Date: August 2, 2017
To: Jason Gilman, Sara Olson
From: Kevin Luecke
Re: South Avenue Multimodal Assessment Steering Committee Meeting #4

South Avenue Multimodal Assessment Steering Committee Meeting
Friday, August 4, 2016
11:00am – 12:30pm
City Hall 3rd Floor Conference Room

PRELIMINARY DRAWING
 RECOMMENDED ALTERNATIVE
 MINIMUM WIDTH WITH ROUNDABOUTS
 US 14 IMPROVEMENTS
 CITY OF LA CROSSE, SOUTH AVENUE
 GREEN BAY STREET TO WARD AVENUE
 LA CROSSE COUNTY
 WISDOT PROJECT ID 1641-02-02
JULY 2017

Date: June 27, 2017
To: Jason Gilman and City of La Crosse Staff
From: Kevin Luecke
Re: WisDOT South Avenue Designs and Recommendations

Relocate the inbound MTU bus stop west of 16th Street to west of 17th Street.

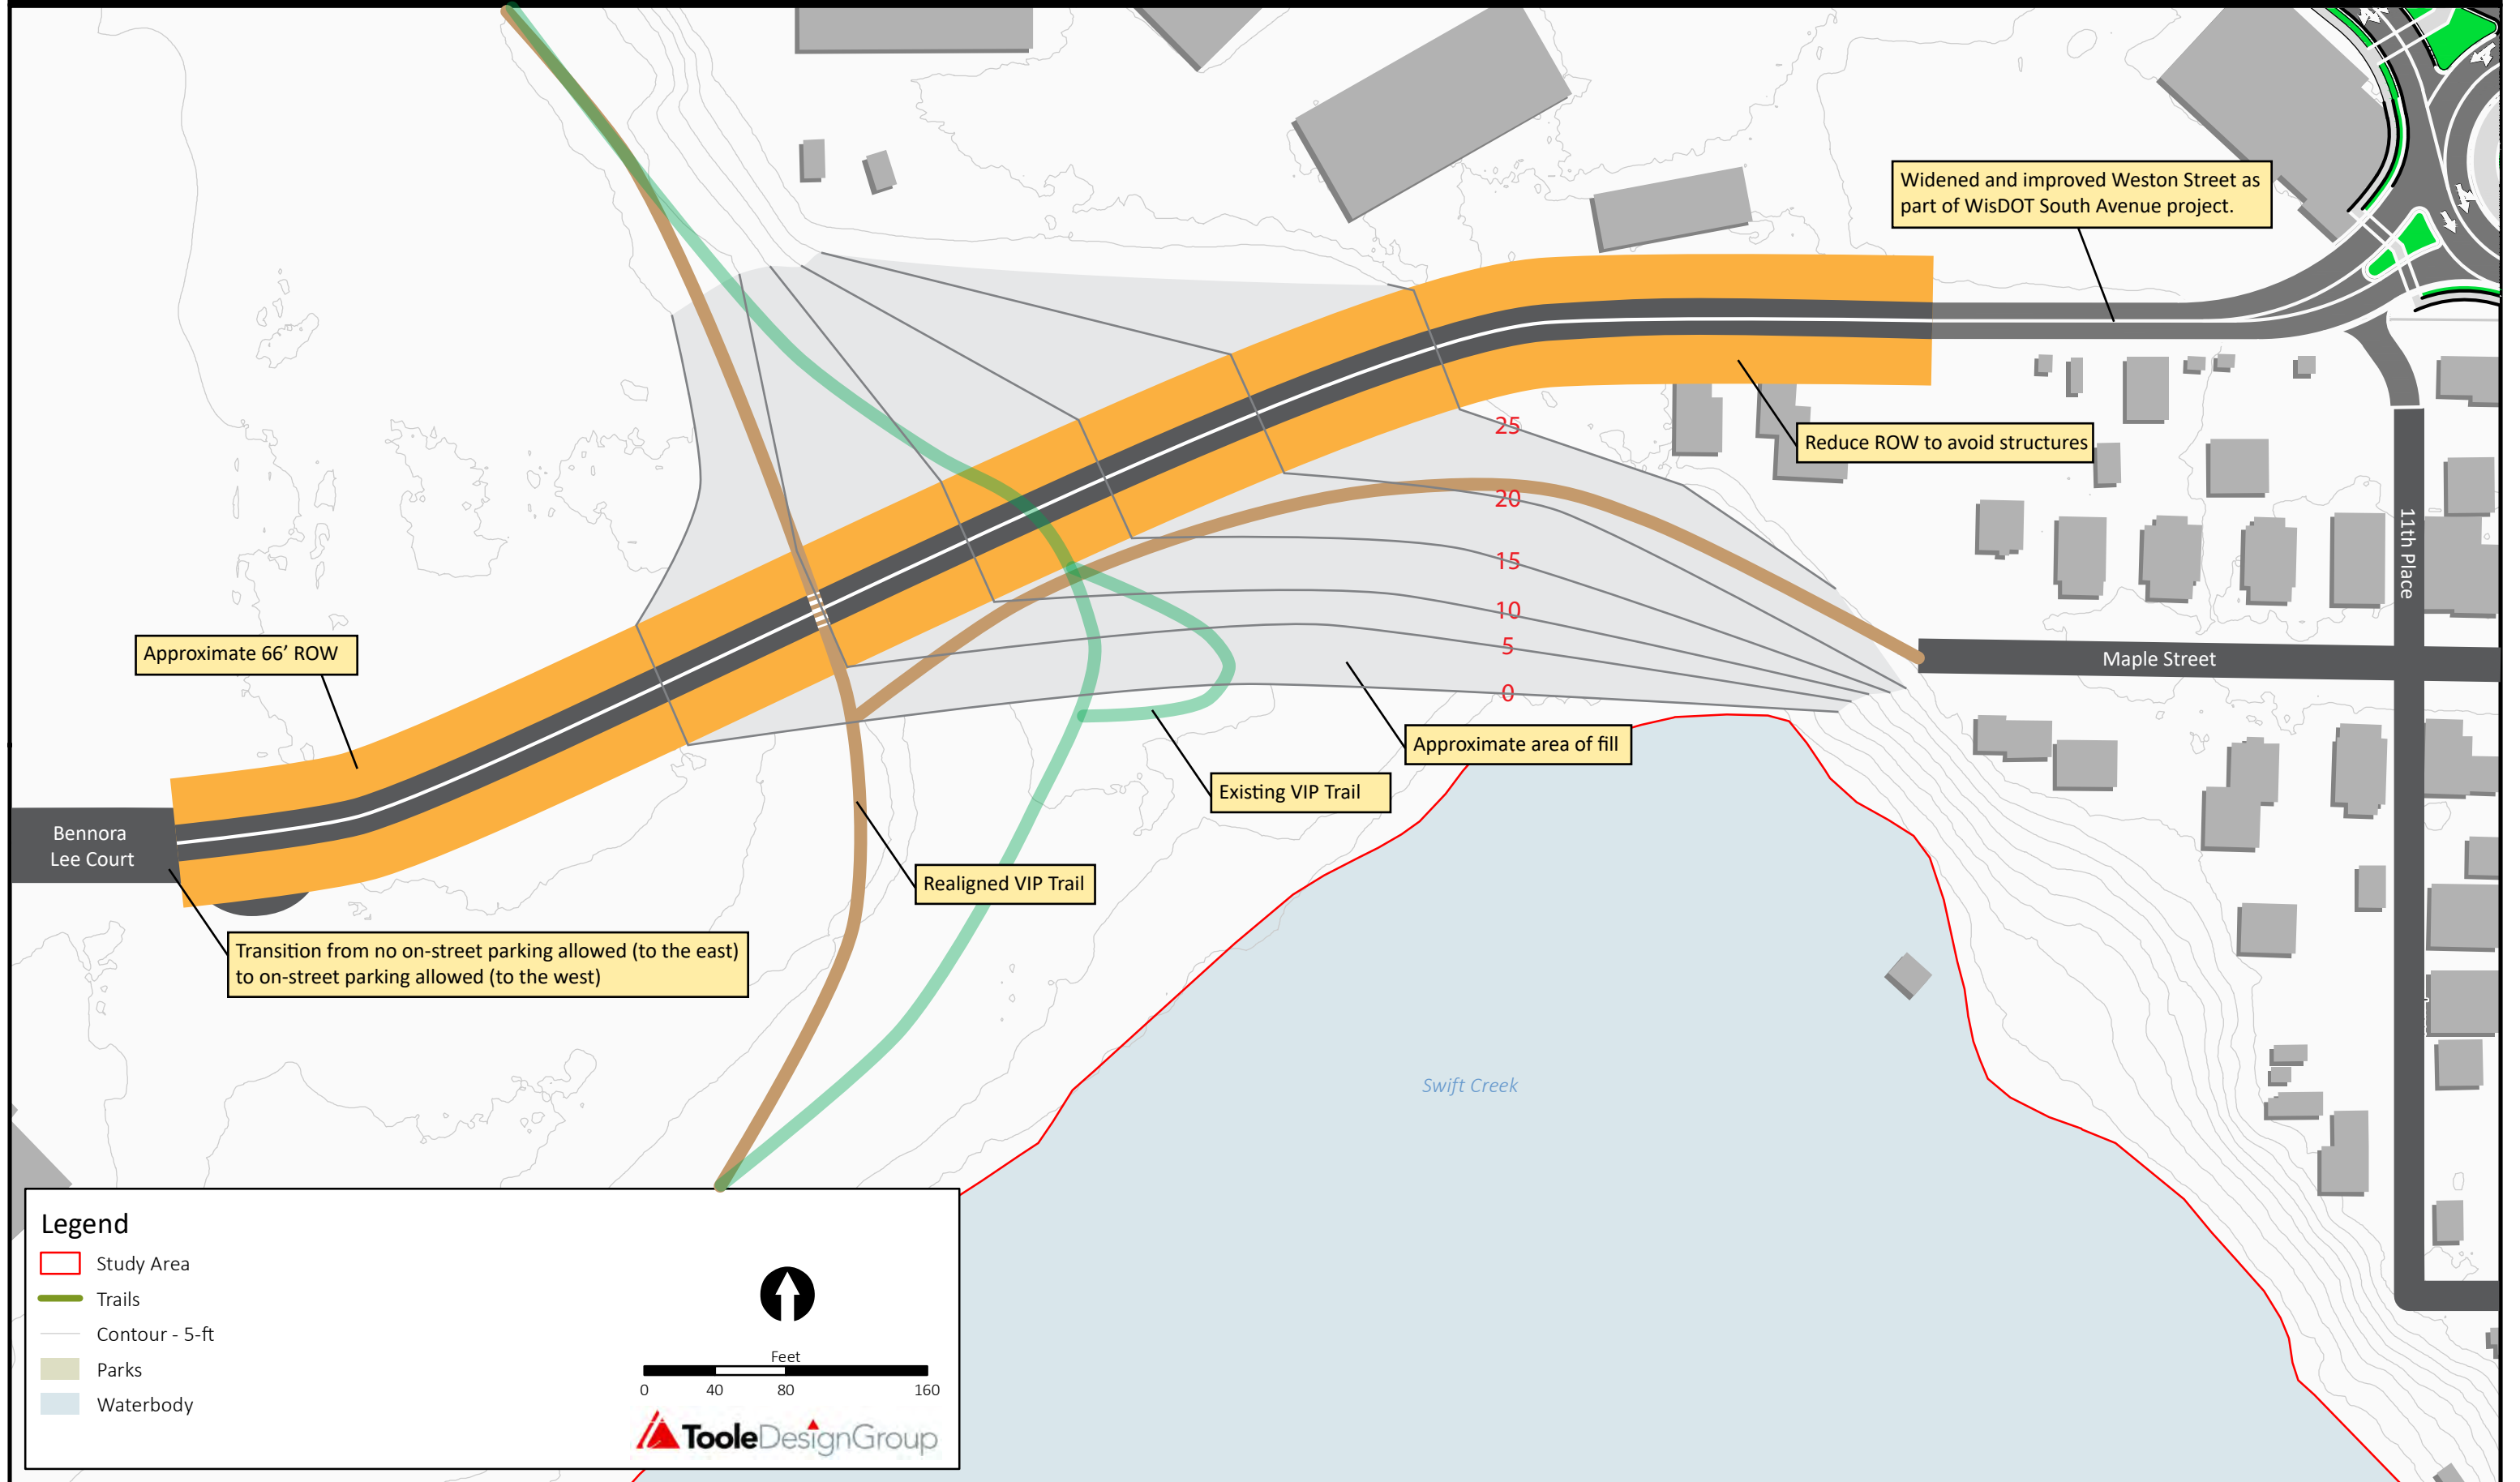
Clients at Riverfront, Inc. currently have a difficult time crossing South Avenue to access the existing bus stop just east of 16th Street. Following reconstruction of the street and the addition of a pedestrian median island and RRFB at 17th Street, the bus stop should be relocated to just west of 17th Street. This location will allow crossing without having to negotiate the roundabout at 16th Street, and will be closer to across the street from the outbound bus stop.
